NOTICE OF FINAL RULEMAKING

TITLE 18. ENVIRONMENTAL QUALITY

ARTICLE 2. PUBLIC AND SEMIPUBLIC SWIMMING POOLS AND SPAS

ILLUSTRATION A. DIVING WELL DIMENSIONS FOR SWIMMING POOLS

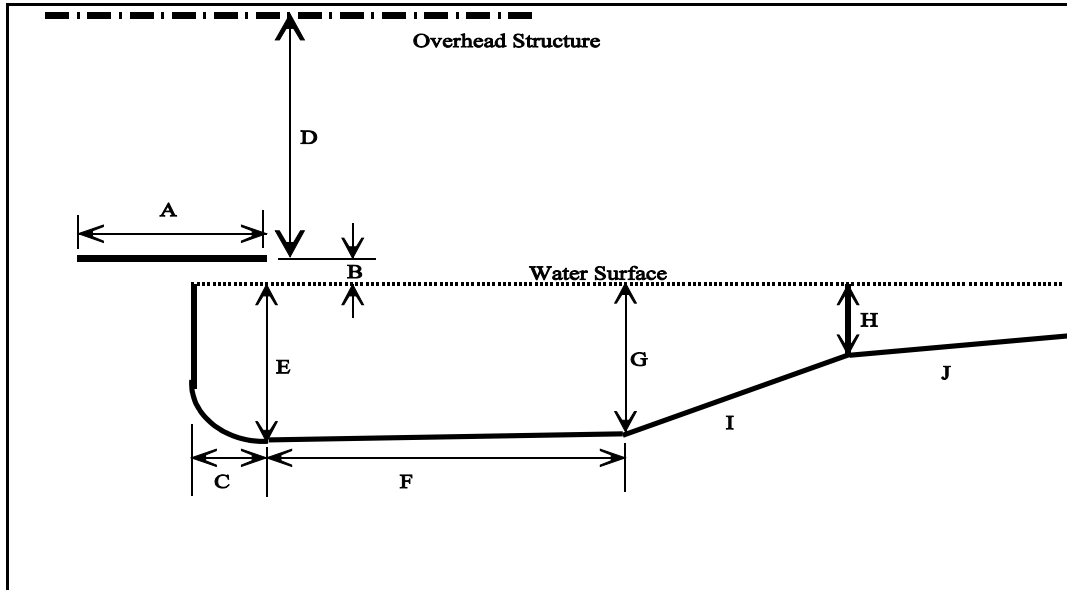
ADEQ added the last sentence to clarify that the diving well dimensions prescribed in Appendix A do not apply to public and semipublic swimming pools that are designed for competitive diving.

ADEQ changed references to "Appendix A" to "Illustration A" to be consistent with the definitions for these terms that have been promulgated by the Office of the Secretary of State. ADEQ added the phrase which permits the use of the international symbol for no diving in response to a public comment.

Note: This profile does not apply to a special use pool that is designed for competitive diving.

ILLUSTRATION B. MINIMUM DISTANCE REQUIREMENTS FOR DECKS

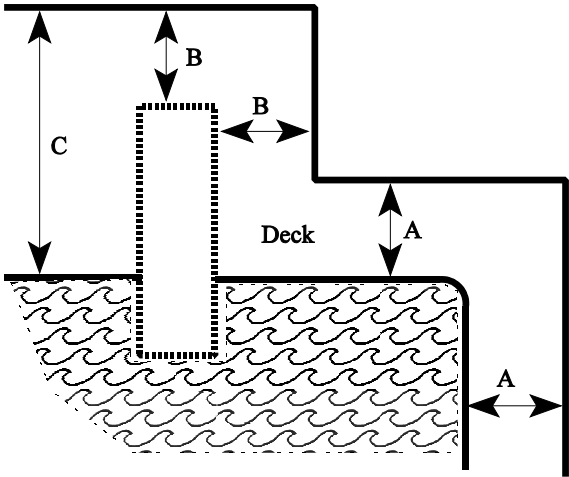
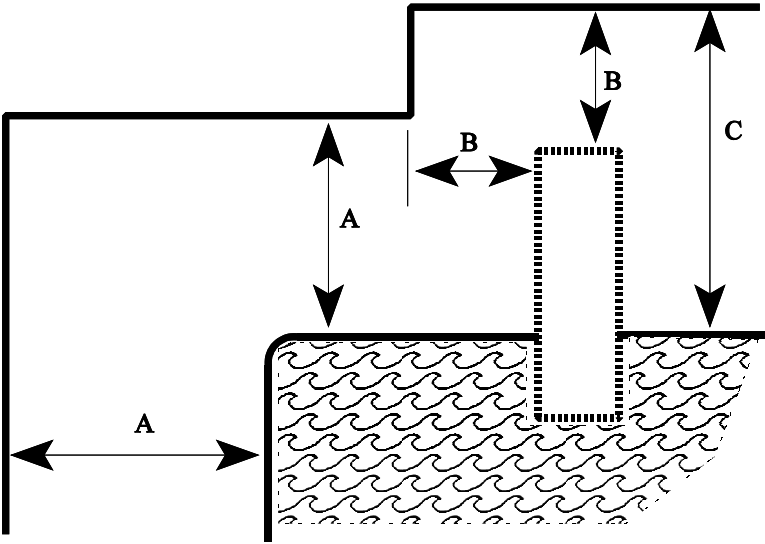
Appendix C. *No change except to rename Appendix C as Illustration B.*
